AMENDMENT TO FACILITY OPERATING LICENSE

Amendment No. 16  
License No. DPR-42

ATTACHMENT TO LICENSE AMENDMENT NOS. 16 AND 10

SAFETY EVALUATION BY THE OFFICE OF NUCLEAR REACTOR REGULATION

FIGURE TS.3.10-5

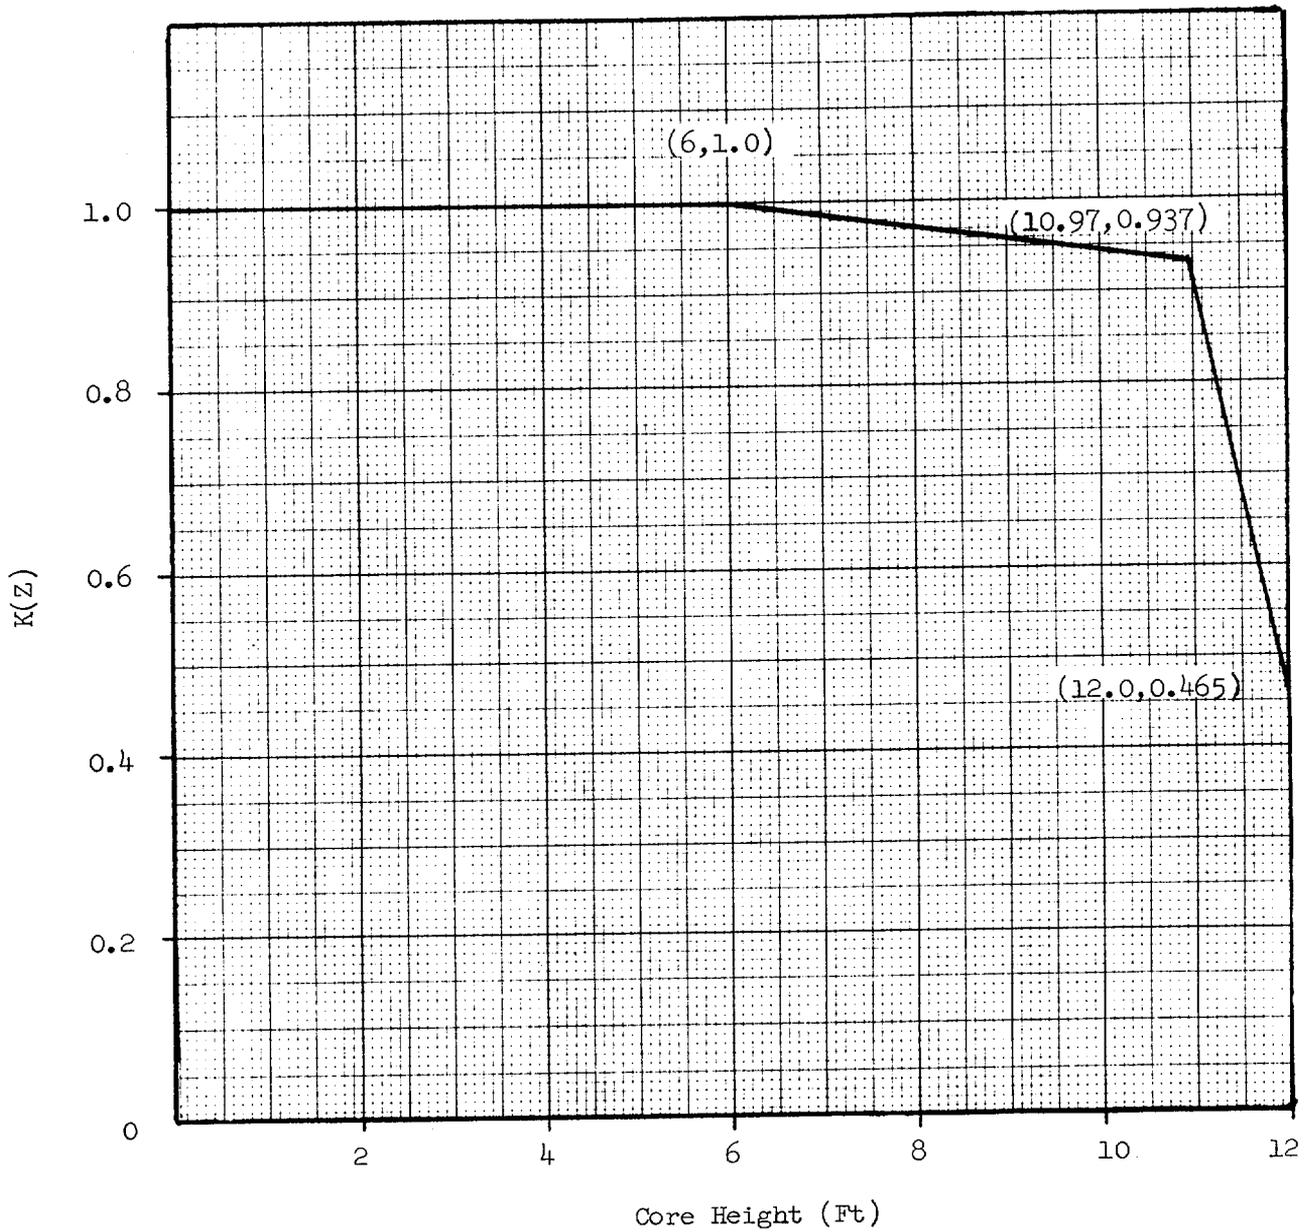
where P is the fraction of full power at which the core is operating. K(Z) is the function given in Figure TS.3.10-5 and Z is the core height location of  $F_Q^N$ .

An upper bound envelope of 2.15 times the normalized peaking factor axial dependence of Figure TS.3.10-5 has been determined from extensive analyses considering all operating maneuvers consistent with the technical specifications on power distribution control as given in Section 3.10. The results of the loss of coolant accident analyses based on this upper bound envelope indicate a peak clad temperature of 2155°F corresponding to a 45°F margin to the 2200°F limit.

The technical specifications on power distribution control assure that the  $F_Q$  upper bound envelope of 2.15 times Figure TS.3.10-5 is not exceeded and xenon distributions are not developed which at a later time, would cause greater local power peaking even though the flux difference is then within the limits specified by the procedure.

FIGURE TS.3.10-7

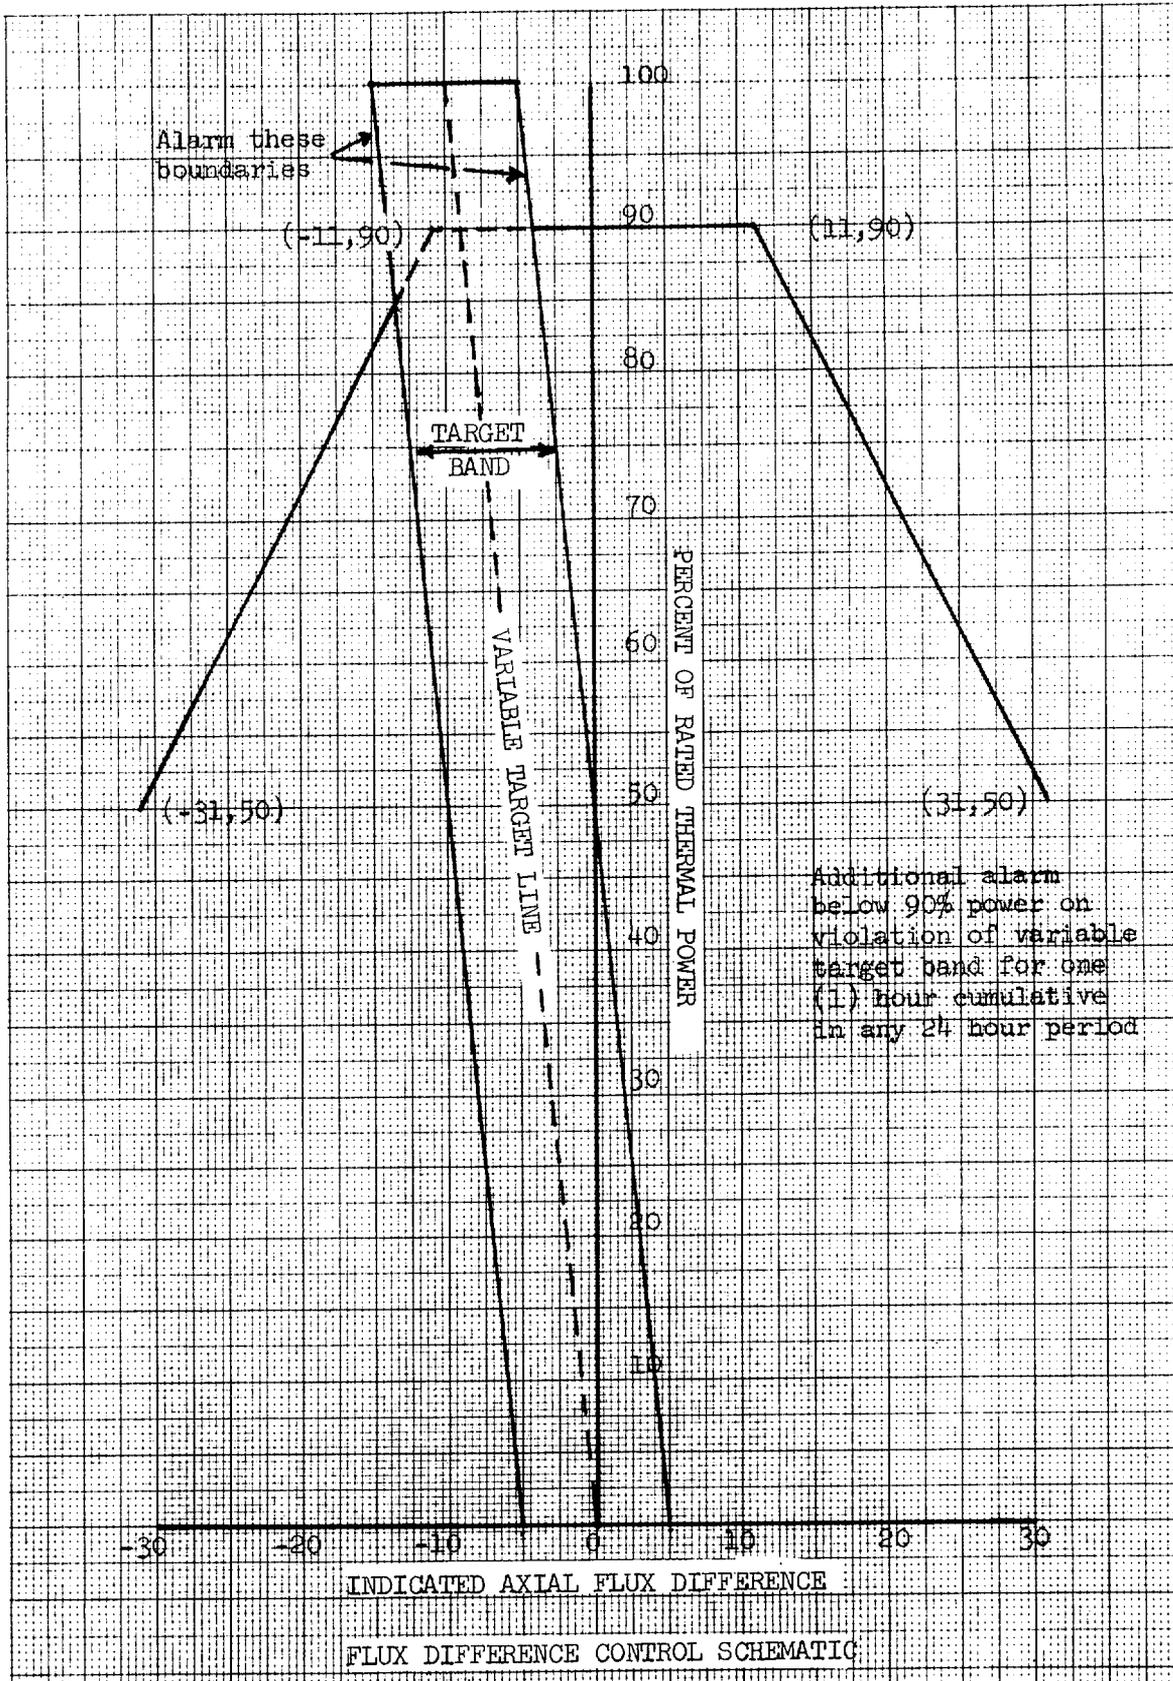
TS 3.10-1  
TS 3.10-2  
TS 3.10-3  
TS 3.10-4  
TS 3.10-7  
TS 3.10-8  
TS 3.10-9  
TS 3.10-10  
TS 3.10-10a (new page)  
TS 3.10-11 (correction of misspelled word only in first line)  
TS 3.10-5  
TS 3.10-6 (new figure)  
TS 3.10-7 (new figure)
